**FINAL FINDINGS AND DECISION BY THE DESIGN
COMMISSION RENDERED ON April 7, 2022**

**CASE FILE NUMBER: LU 21-108433 DZ – ARGYLE HOUSING
PC # 20-202695**

Type III Design Review for construction of approximately 290 residential units in an eleven-story building in the Kenton Plan District. The project site includes two parcels totaling 25,000 SF adjacent to the Kenton / North Denver Avenue MAX light rail station. The project includes main entrances along both street frontages, outdoor areas at the ground level and the rooftop, individual balconies, and common spaces through the building. A composite rain screen cladding is proposed above a concrete base with metal storefront systems at the ground level.

1/16" = 1'-0"

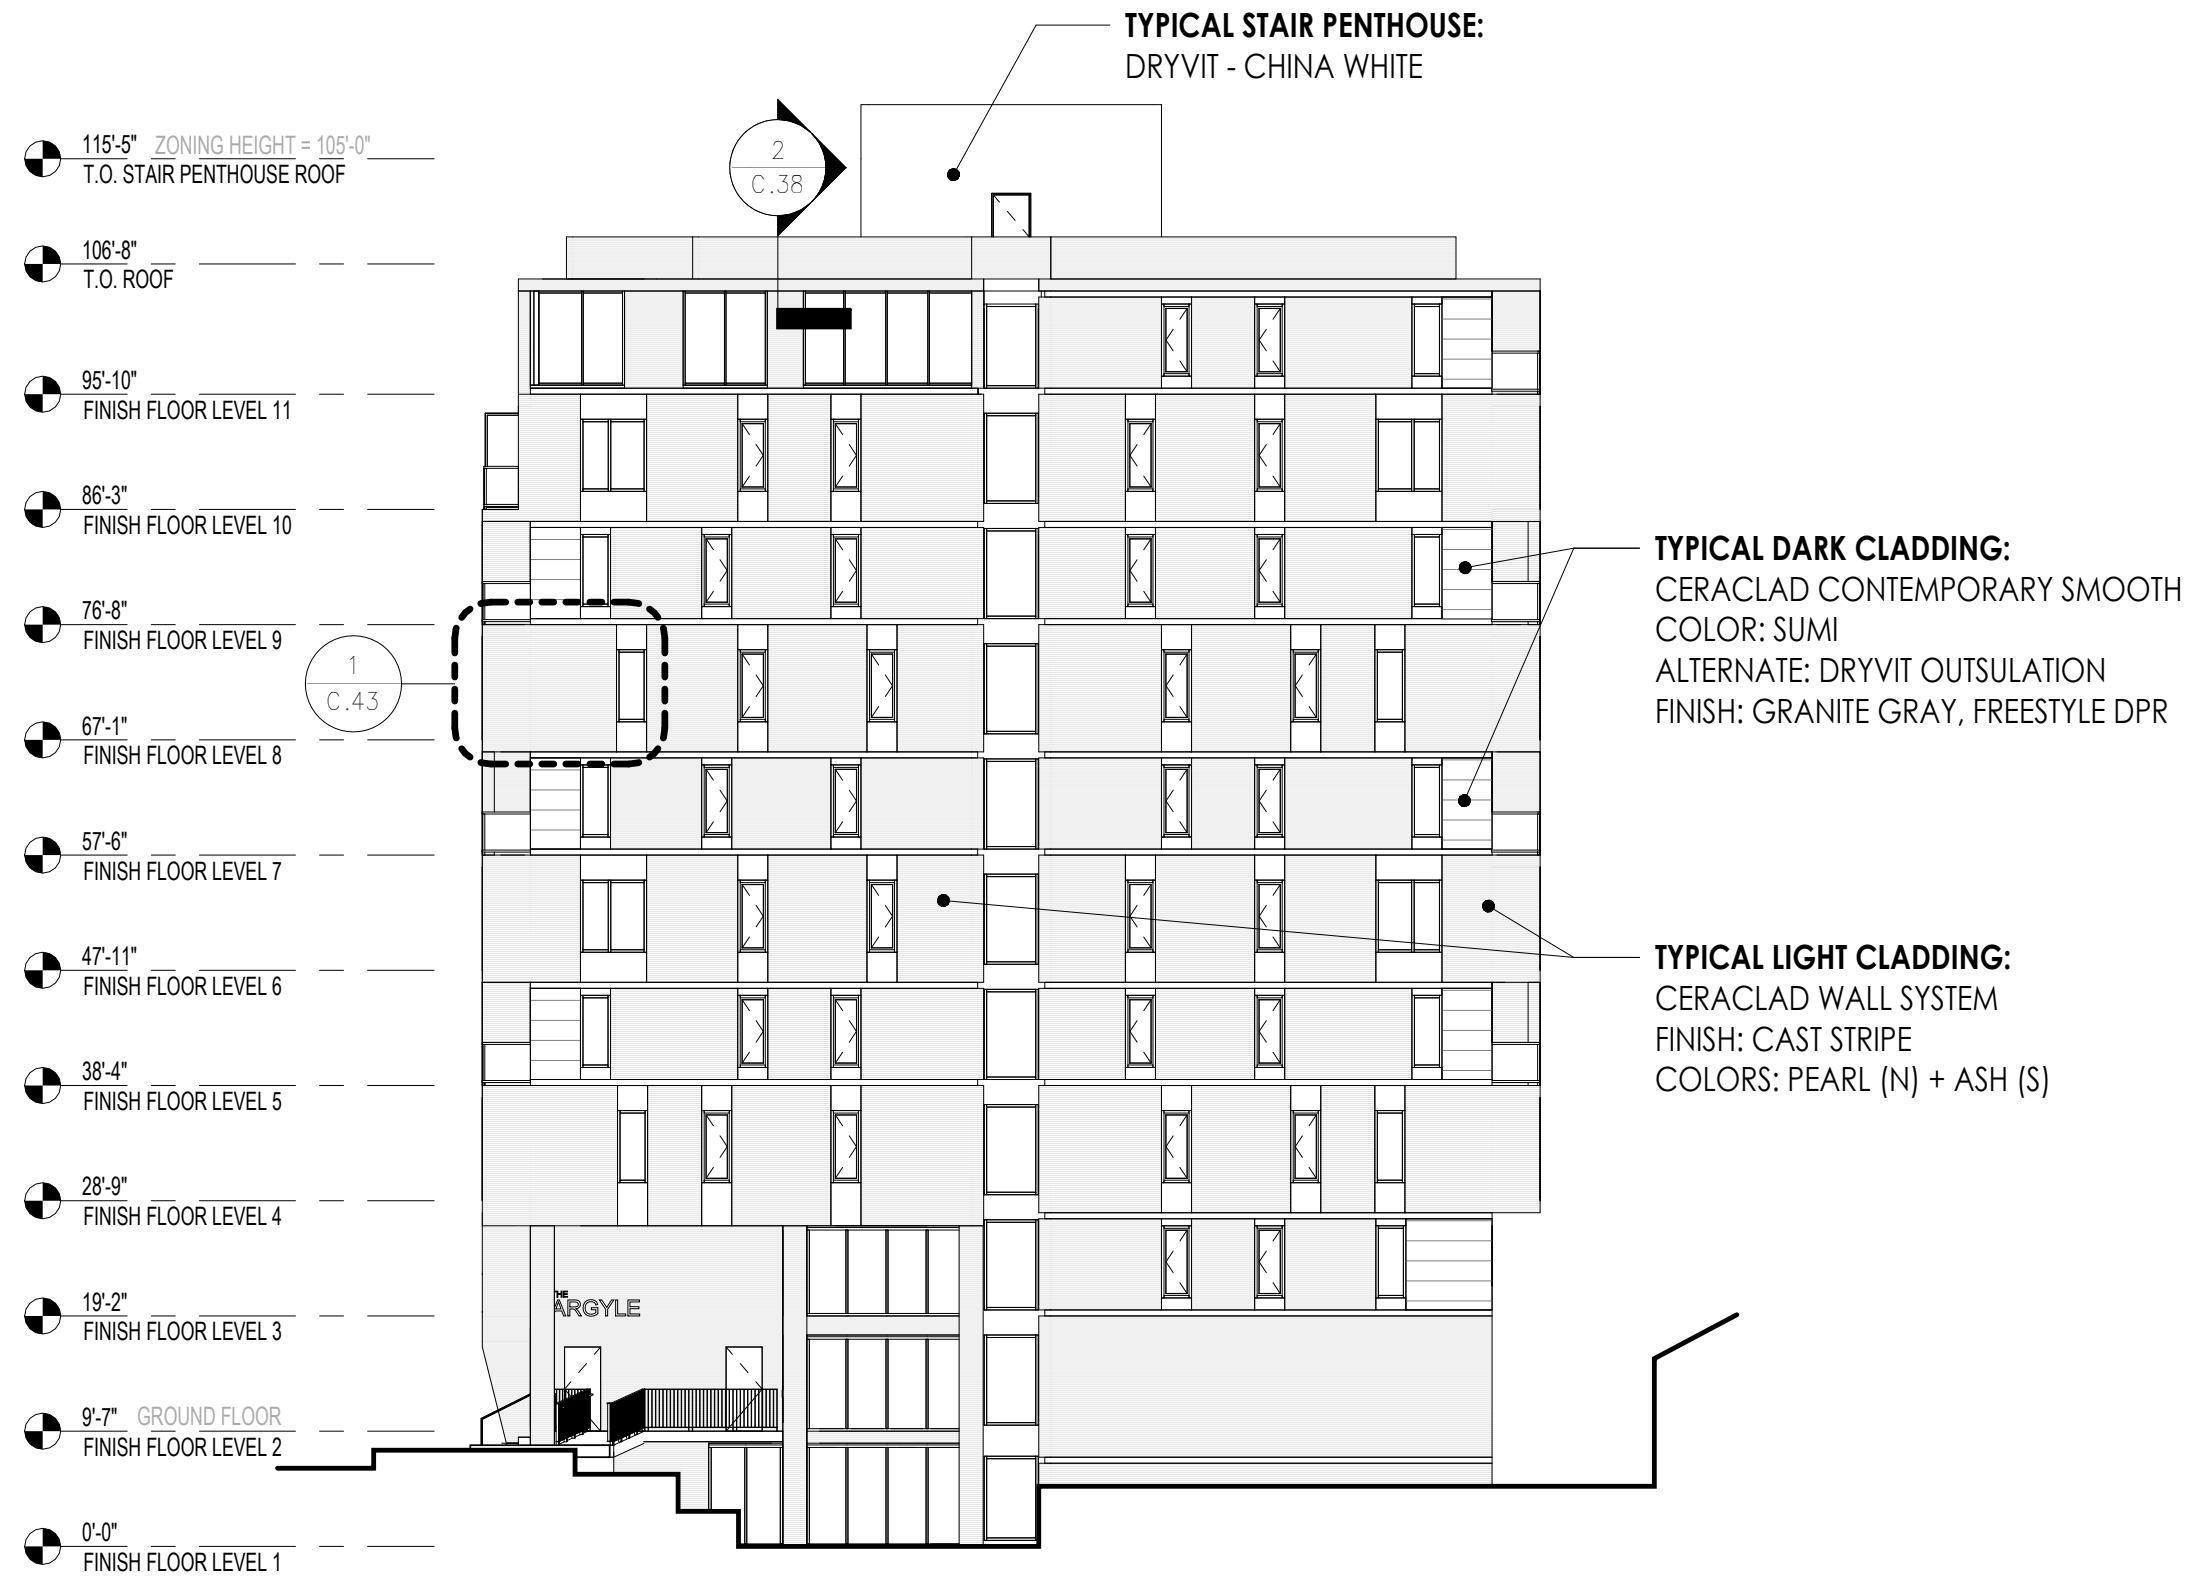
- 4. Cera-clad and Dry-Vit: The Commission was split on Dryvit.**
Response: The primary design (C.60) is still proposed as primarily Ceraclad, with Alternate 1 (C.61) proposed as a VE alternate, with Dryvit only in areas that are recessed within balconies and not at high exposure. Alternate 2 (C.62) has been eliminated. C.8, C.9, C.10, C.11, C.60, C.61, C.62.
